Synopsis

This report concerns an application to demolish existing improvements and Torrens title subdivision of the site into 2 allotments and construct and fit out a 13,350sqm Masters Home Improvement store including vehicle access, loading, car parking and landscaping on Lot 1 and construct 10 industrial units varying from 348sqm to 635sqm including vehicle access, loading, car parking and landscaping on Lot 2.

DA No: 201500168

Image 8: Amended floor plans of proposed industrial units on Lot 2

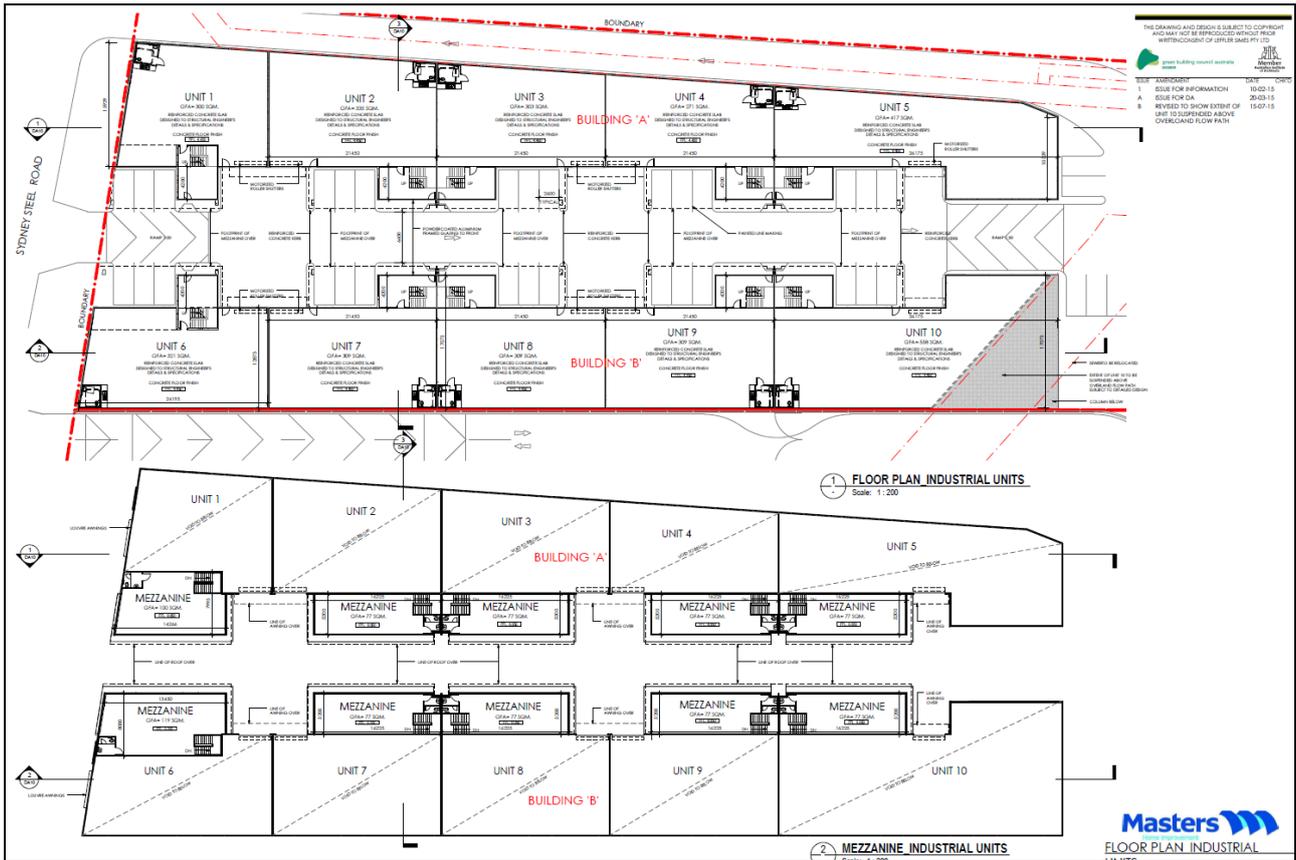
Amended plans provided illustrate that Unit 10 of the development is elevated/suspended above the natural ground level to ensure the building does not obstruct the overland flow path. However insufficient detail is provided on the plans to demonstrate that this unit complies with accessibility requirements as per Part 2.5 of MDCP 2011. A condition is included in the recommendation of this report requiring the subject building to be accessible in accordance with Council's requirements and the Access to Premises Standards for a new building, with amended plans being provided before the issue of a Construction Certificate illustrating the provision of an accessible principle entry.

The amended application does not propose any accessible car parking spaces on this site. The proposal is required to provide 21 car spaces in accordance with parking rates prescribed by Part 2.10 (Parking) of MDCP 2011 of which 3 spaces are required to be accessible. The proposed development provides a total of 33 car parking spaces, as such the loss of parking spaces to facilitate accessible parking is considered reasonable and is unlikely to affect the operation of the industrial complex. The requirement for amended plans to reflect a revised car parking layout illustrating the provision of 3 accessible car parking spaces is included in the recommendation of this report.

Image 11: Portion of building extending over the SP2 zone is highlighted in blue

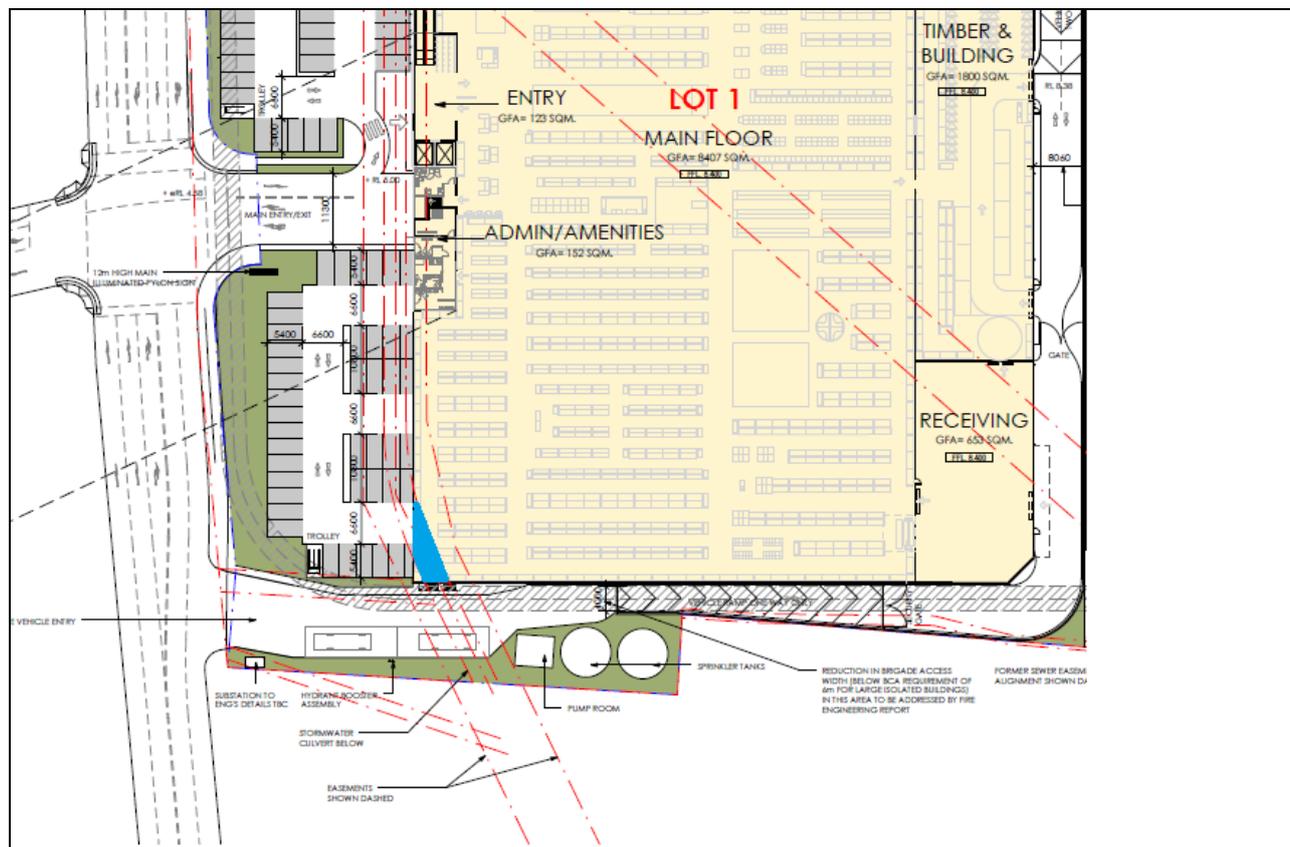
It is proposed that a small portion (north western corner) of the Masters Building extend over the SP2 zone. The portion of the building extending over the SP2 zone is illustrated below;

Clause 5.3(4) identifies that development consent may be granted to development of land to which this clause applies “for any purpose that may be carried out in the adjoining zone”. The proposal for a “garden centre and hardware and building supplies” is not permitted in the adjoining IN1 zone as it is a form of retail / commercial premises which is a prohibited use in the zone. While Schedule 1 of MLEP permits a “garden centre and hardware and building supplies” as an additional permitted use on Lot 202 in DP 1133999, Clause 5.3(4) does not refer to permitted uses on adjoining lots but specifically refers to “adjoining zones”. Accordingly Clause 5.3(4) does not permit the “garden centre and hardware and building supplies” allowed on Lot 2 in DP 1133999 to be expanded into the SP2 zone.

To overcome permissibility constraints relating to the Masters building, a deferred commencement condition is included in the recommendation that requires the building footprint to be slightly amended such that it is located entirely on Lot 2 in DP 1133999 being that land zoned IN1 General Industrial that is also referred to in Schedule 1 – Additional Permitted Uses of MLEP 2011. Whilst this amendment would result in the provision of a splay on this corner of the building and result in the loss of approximately 36sqm of GFA, the design change would not be detrimental to the functioning, operation or overall appearance of the development.

- Amended plans being submitted to the satisfaction of the Council demonstrating the introduction of a splay in the north western corner of the Masters building to ensure that the built form of the hardware and building supplies centre does not extend over Lot 3 in DP180969 being a portion of the stormwater easement zoned SP2 – Stormwater Management Systems.
